CONNECTION ASSESSMENT & APPROVAL PROCESS

ASSESSMENT SUMMARY

Project: Nickel Rim Mine Substation

CAA ID No. 2003-EX174

DIAGRAM 9

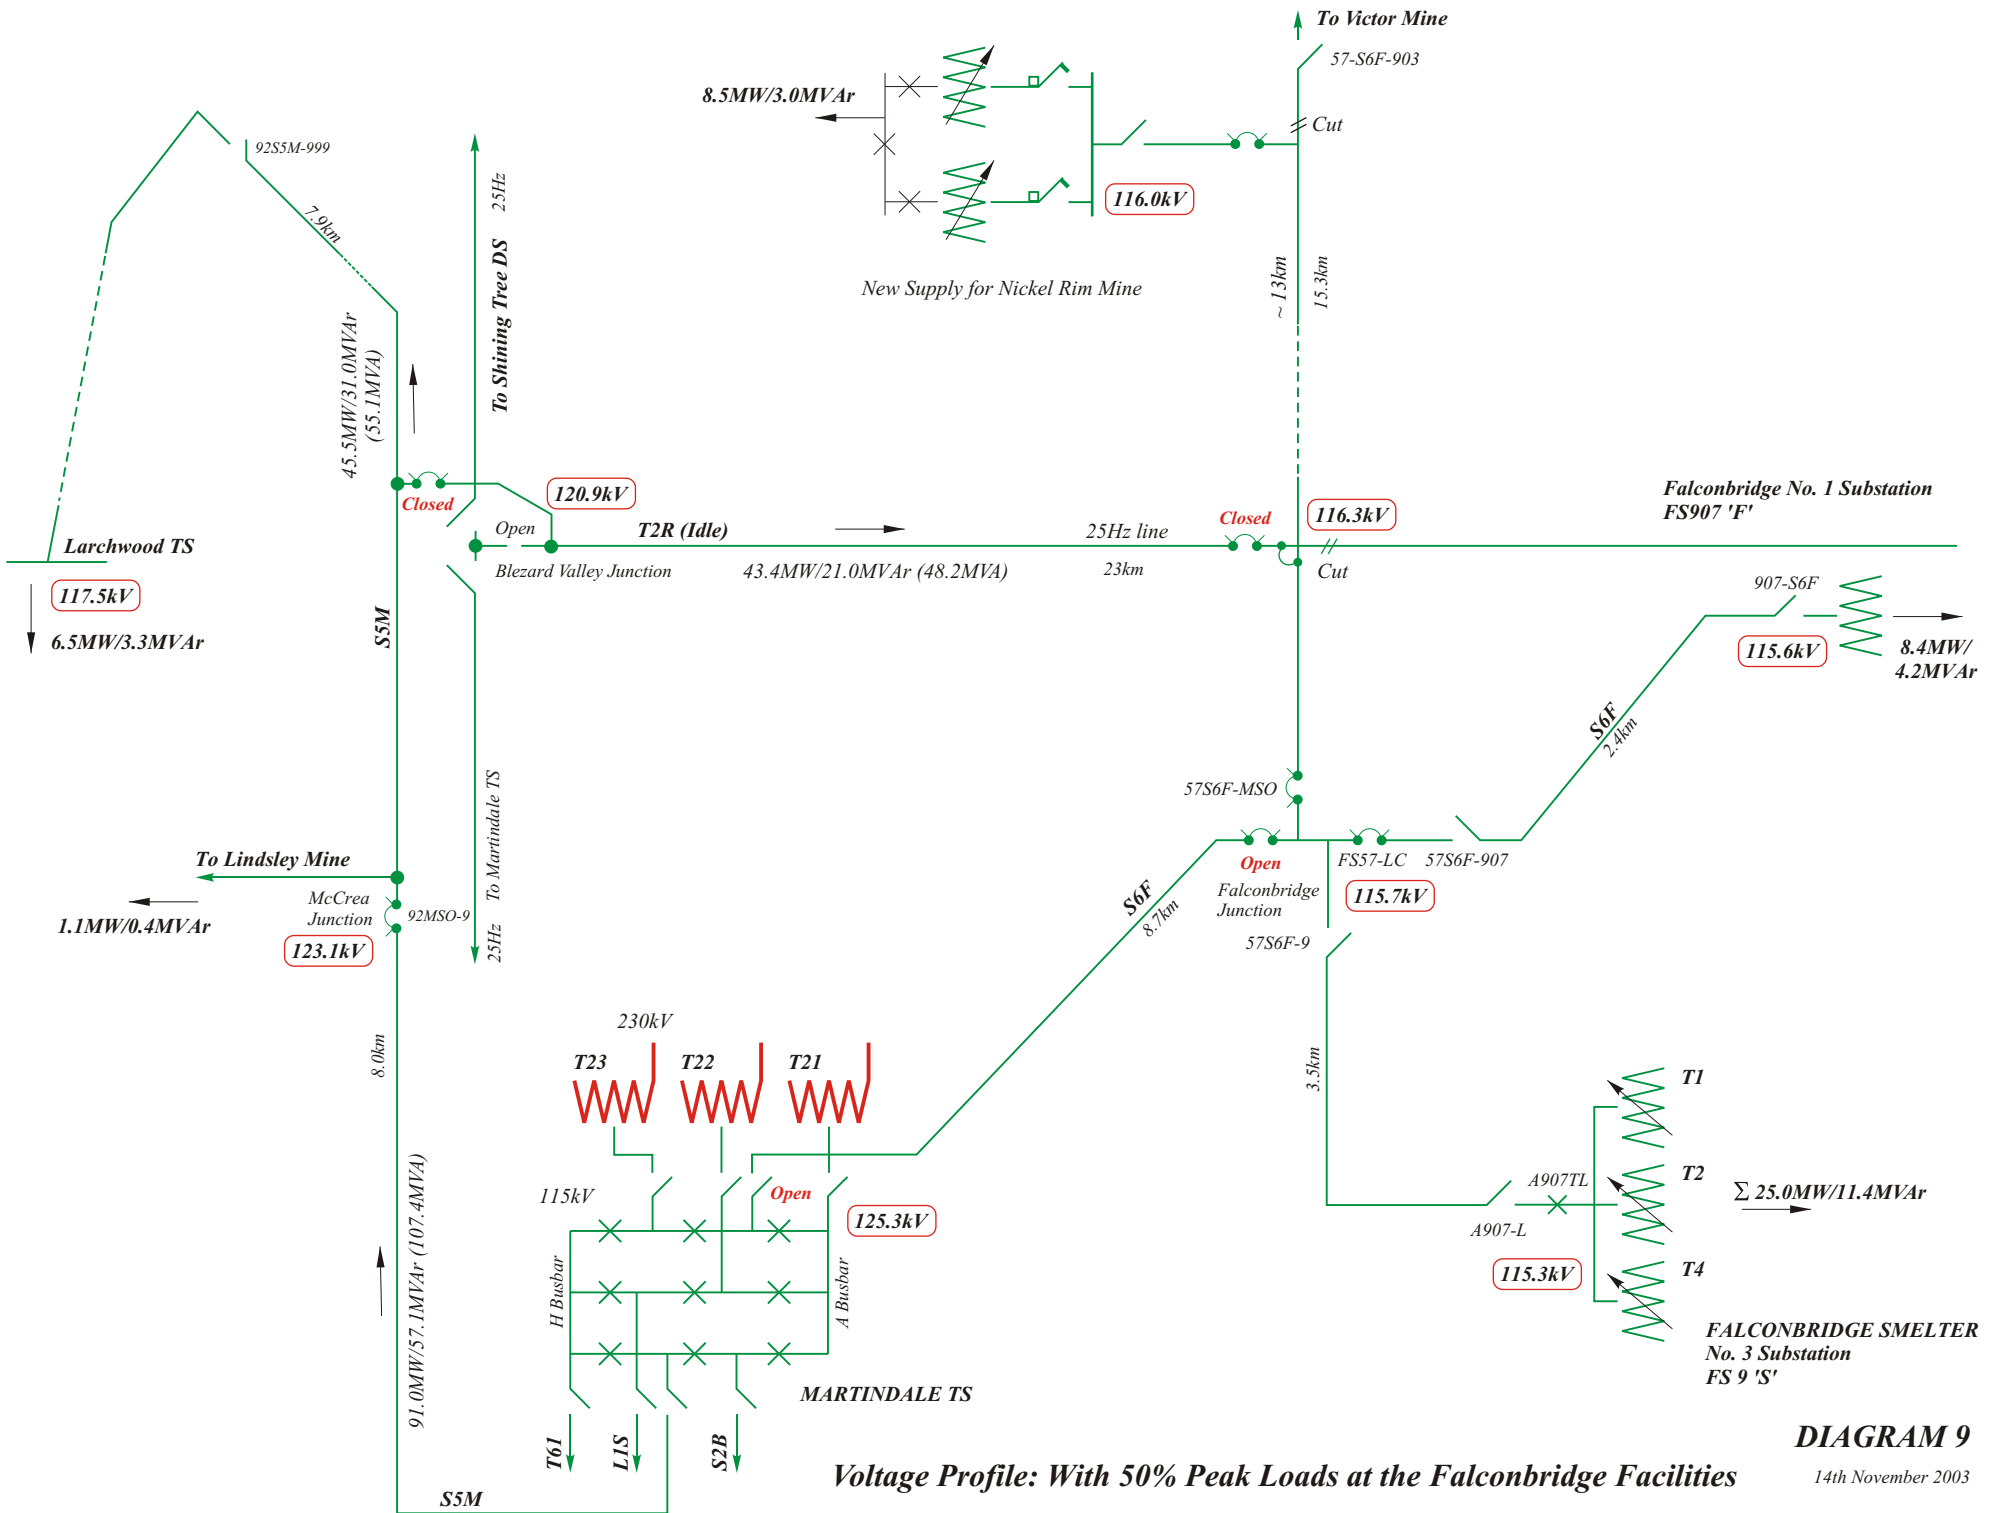
Diagram 9 shows the results of a load flow study with circuit S5M supplying a load of approximately 50MVA, which corresponds to the present peak loading on this circuit. The loads at the various Falconbridge facilities supplied from circuit S6F have been reduced to approximately half their peak values, as follows:

The corresponding flows on circuits S5M and T2R are shown as 107MVA and 48MVA, respectively. These would be within the respective continuous ratings of 177MVA and 54MVA for these two circuits.

The minimum voltages that were recorded were 115.6kV at Falconbridge No. 1 Substation and 117.5kV at Larchwood TS. While these are both above the minimum voltage of 113kV specified in the Market Rules, it should be noted that these voltages correspond to a relatively high voltage of 125.3kV at Martindale TS.

Therefore, should Falconbridge decide to have the temporary connection on to circuit S5M restored for use during planned outages involving the section of circuit S6F between Martindale TS and Falconbridge Junction, *then as long as the voltage at Martindale TS can be maintained above 125kV*, it should be possible to supply a load of approximately 50MVA at the Falconbridge facilities (effectively limited by the continuous rating of circuit T2R). The study has shown that this amount of load could be supplied while still supplying the peak loads on circuit S5M.

However, with lower voltages at Martindale TS it would only be possible to supply a load of approximately 50MVA at the Falconbridge facilities if the loading on circuit S5M were to be reduced, possibly by transferring some of the loads on this circuit to circuit S2B.

Since the temporary connection on to circuit S5M would allow a significant amount of load to be supplied at the Falconbridge facilities under outage conditions, there would therefore appear to be some merit in installing facilities at Falconbridge Junction that would facilitate the restoration of the temporary connection and also limit any disruption of the supply to the Falconbridge loads while the connection is being restored.
